CITY PLAN COMMISSION**THURSDAY, JULY 10, 2025****RECORD NO.:** PLAT-25-000030 (S245-197) **SENIOR PLANNER:** Sharmila Shrestha**LOCATION:** Singleton Boulevard, at the terminus of Duluth Street**DATE FILED:** June 13, 2025**ZONING:** PD 1049**PD LINK:** <https://dallascityhall.com/departments/city-attorney/pages/articles-data.aspx?pd=1049>**CITY COUNCIL DISTRICT:** 6**SIZE OF REQUEST:** 32.351-acres**APPLICANT/OWNER:** Villages at Soho Square, LLC

REQUEST: An application to replat a 32.351-acre tract of land containing part of City Block 7254, part of Lot 4, all of Lots 5, 9 through 12 in City Block 5/7252, all of Lots 1 through 12 in City Block 6/7252, all of Lots 2 through 6 and Lots 10 through 12 in City Block 7/7252 and abandoned portions of Munice Avenue and Bayonne Street to create one lot on property located on Singleton Boulevard, at the terminus of Duluth Street.

PRELIMINARY PLAT - LOT 1, BLOCK A / 7254, VILLAGES AT SOHO

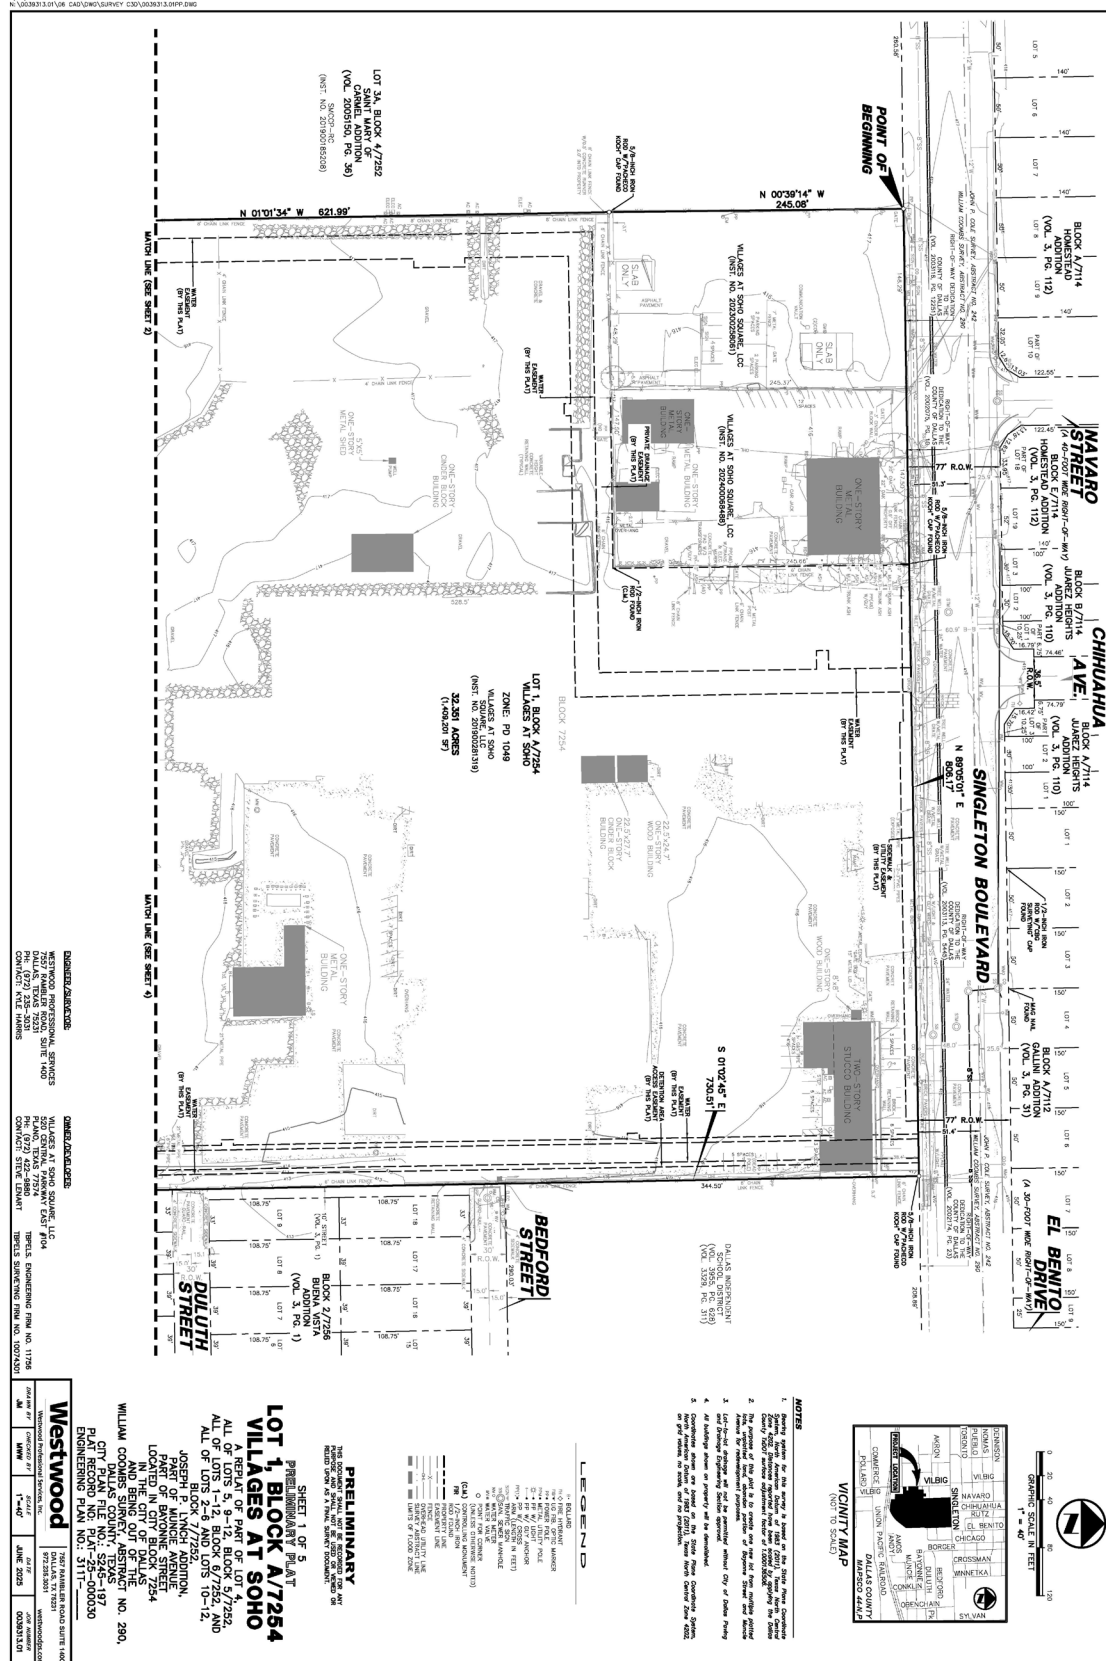
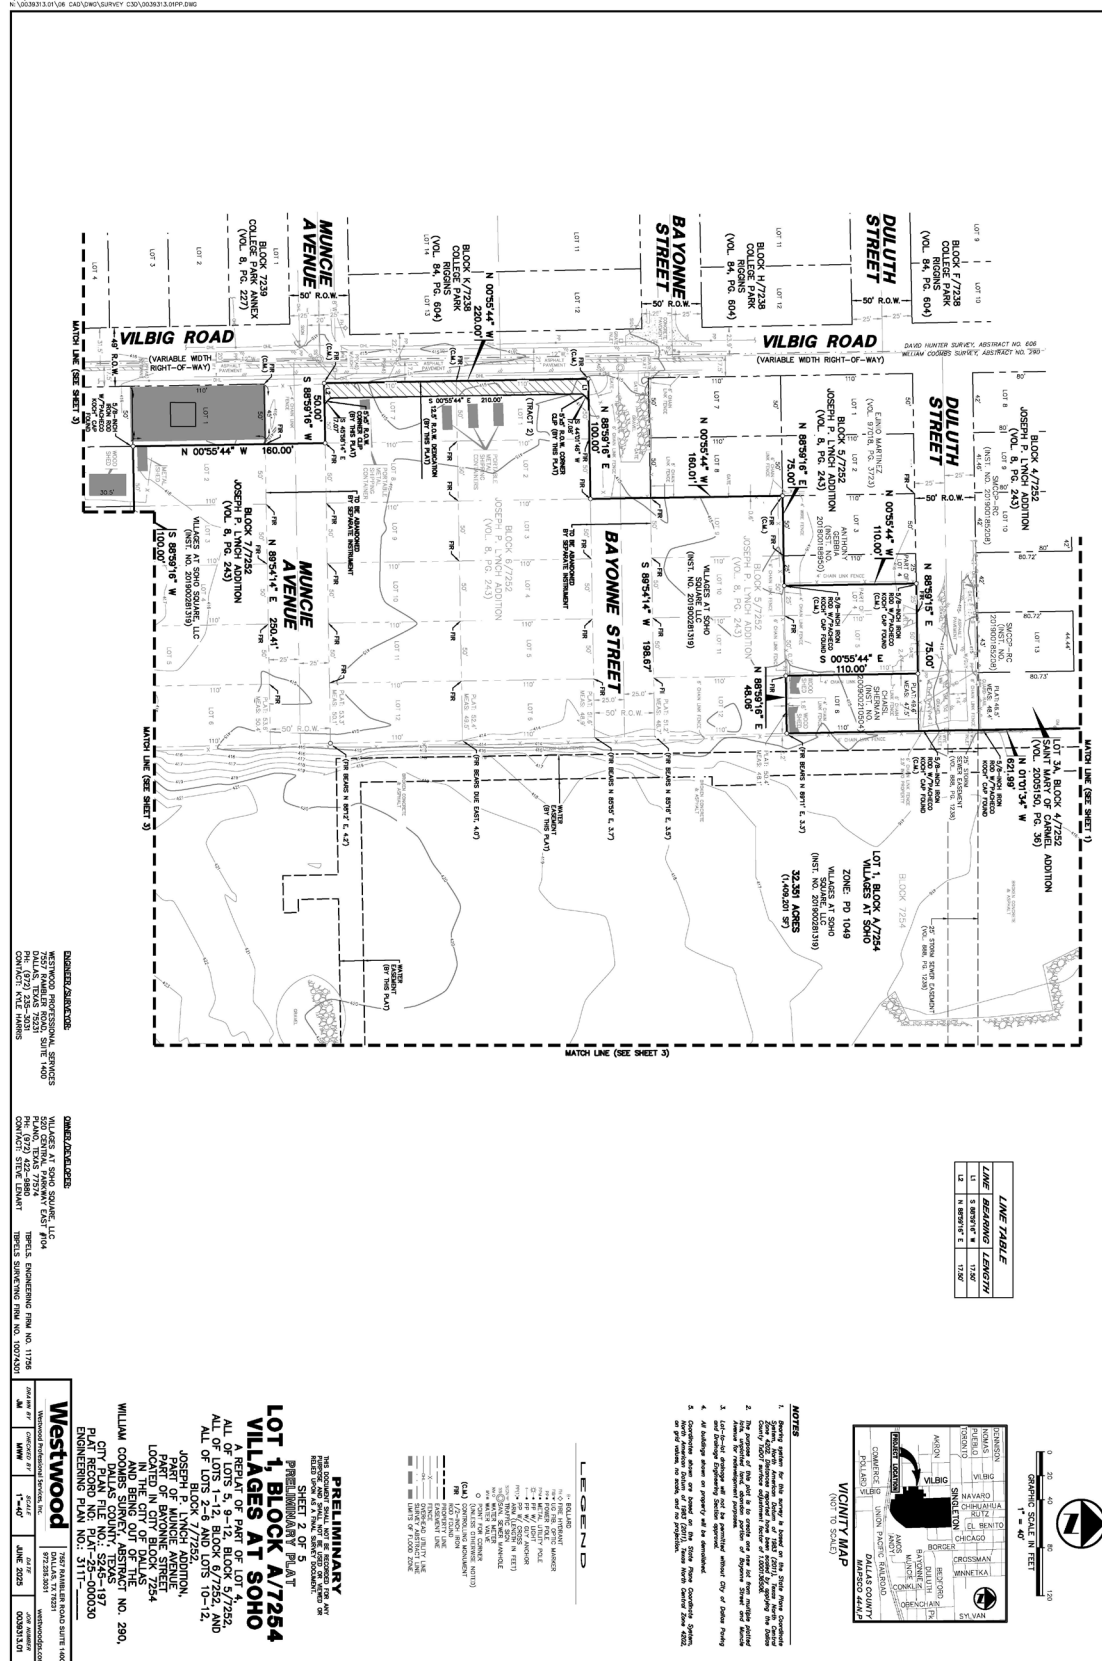
1. The final plat must conform to all requirements of the Dallas Development Code, Texas Local Government Code, Texas Land Surveying Practices Act and the General Rules and Regulations of the Texas Board of Land Surveying.
2. Department of Development Services, Engineering Division must verify that the plat conforms with the water, wastewater, and easement requirements under the provisions of Chapter 49 of the Dallas City Code.

3. Compliance with all plans, contracts, ordinances, and requirements of the City of Dallas. *Section 51A-8.102(a), (b), (c), and (d)*
4. The number and location of fire hydrants must comply with the Dallas Fire Code.

5. Any new or existing structure may not extend across new property lines. *Section 51A-8.503(e)*
6. On the final plat, all easement abandonments, and ROW abandonments must be by separate instrument with the recording information shown on the face of the plat. A release from the Real Estate Division is required prior to the plat being submitted to the Chairman for signature.

7. On the final plat, include two boundary corners tagged with these coordinates: "Texas State Plane Coordinate System, North Central Zone, North American Datum of 1983 on Grid Coordinate values, No Scale and no Projection."

8. On the final plat, monument all set corners per the Monumentation Ordinance. Prior to submittal of the final plat for the Chairman's signature. The monuments must be verified by the Chief City Surveyors Office in the Public Works Department. *Section 51A-8.617*

9. Provide ALL supporting documentation (i.e. deeds, plats, ordinances, easements...etc) with a completed Final Plat Checklist to the Survey Plat Review Group (**SPRG**) with the Final Plat Submittal **after** City Plan Commission Approval.

10. Prior to the final plat, submit a tree survey to the Arborist. A release from the arborist is required prior to an early release request or the recordation of the plat, whichever occurs first.

11. The number of lots permitted by this plat is one.

12. Submit a full set of Civil Engineering Plans (drainage, paving, street signage/marketing/lighting) prepared per City Standards by a licensed (TX) Professional Engineer to Engineering Division in Room 200, Oak Cliff Municipal Center (i.e. 311T/DP). Additions and alterations to the public infrastructure require approval and may require private development contracts with bonds. 51A-8.102 (c); 8.601(b)(4),(5),(6),(7),(8),(9)
13. Detention may be required if the capacity of available outfall is not adequate to carry the developed runoff. *Section 51A-8.611(c)*.
14. Place a note on the final plat stating "Lot-to-Lot drainage will not be allowed without proper City of Dallas Engineering Division approval" 51A 8.611(e)
15. Existing drainage conveyance within the property is required to be sized in compliance with *Section 51A-8.611(a)(1)* of the City of Dallas Code.

16. On the final plat, dedicate 50 feet right-of-way (via fee simple) from the established centerline of Singleton Boulevard. *Section 51A 8.602(c)*
17. On the final plat, dedicate 30 feet right-of-way (via fee simple) from the established centerline of Vilbig Road. *Section 51A 8.602(c)*

18. On the final plat, dedicate 25 feet of right-of-way (via fee simple or street easement) from the established centerline of Pablo Street. *Sections 51A-8.602(c), 51A-8.604(c) and 51A-8.611(c).*

19. On the final plat, dedicate 28 feet of right-of-way (via fee simple or street easement) from the established centerline of Duluth Street. *Sections 51A-8.602(c), 51A-8.604(c) and 51A-8.611(c).*

20. Must coordinate with Transportation Department for any traffic signal requirements that are deemed necessary for improving pedestrian accessibility and safety related to site development (Contact Srinivasa Veeramallu with Traffic Signals). *51A-8.606, 51A-8.608*

21. Submit a completed Final Plat Checklist and All Supporting Documentation.
22. On the final plat, add/show Lien Holders Subordination Agreement.
23. On the final plat, show how all adjoining right-of-way was created.
24. List utility easements as retained within street abandonments when stated in ordinance or follow the City of Dallas standard affidavit requirements.
25. Ensure no building encroachments.

26. Plans must comply with the traffic barrier requirements. *Section 51A-8.618.*
27. Plans must comply with sidewalk design standards.

28. Additional design information is required for assessment. Site plan must be submitted showing proposed development, building finished floor elevation, development, existing mains – including downstream manhole, and proposed water and wastewater service locations. Submit water/wastewater engineering plans to 320 E. Jefferson Blvd., Room 200, Attention: Water and Wastewater Engineering.
29. Water and wastewater main improvements are required by Private Development Contract. Submit water/wastewater Engineering Plans to 320 E. Jefferson Blvd., Room 200, Attention: Water and Wastewater Engineering.
30. Existing and any proposed Water and Wastewater Easements must be shown and/or increased to conform to current design standards. **Notice:** Minimum DWU

easement size 20' for one utility and 25' for both water and sewer. Larger diameter or deeper mains may require additional width.

31. Submit a full set of Street Lighting plans prepared per City Standards to daniel.silva1@dallas.gov. Street Lighting requirements are determined during the initial phase of review. Additional street lighting installations may be required to meet the photometric requirements of the 2019 Street Design Manual, Section 6. Photometric analysis will be required to support the submitted street lighting plan.

32. On the final plat, show abandonment for Bayonne Street and Muncie Avenue as: Abandonment authorized by Ordinance No. _____, recorded as Vol. Nos. (Cert. ORD No. _____, QCD No. _____). Utility Easements retained.

33. On the final plat, change "Singleton Boulevard" to "Singleton Boulevard (FKA Eagle Ford Road)".
34. On the final plat, change "Navaro Street" to "Navaro Street (FKA Homestead Avenue)".

35. On the final plat, change "Bedford Street" to "Bedford Street (FKA Pate Street)".
36. On the final plat, change "Duluth Street" to "Duluth Street (FKA Kittrell Street)".

37. On the final plat, change "Vilbig Road" to "Vilbig Road (FKA Robinson Road)".
38. On the final plat, change "Elevato Drive" to "Elevado Drive".
39. On the final plat, identify the property as Lot 1 in City Block A/7254.
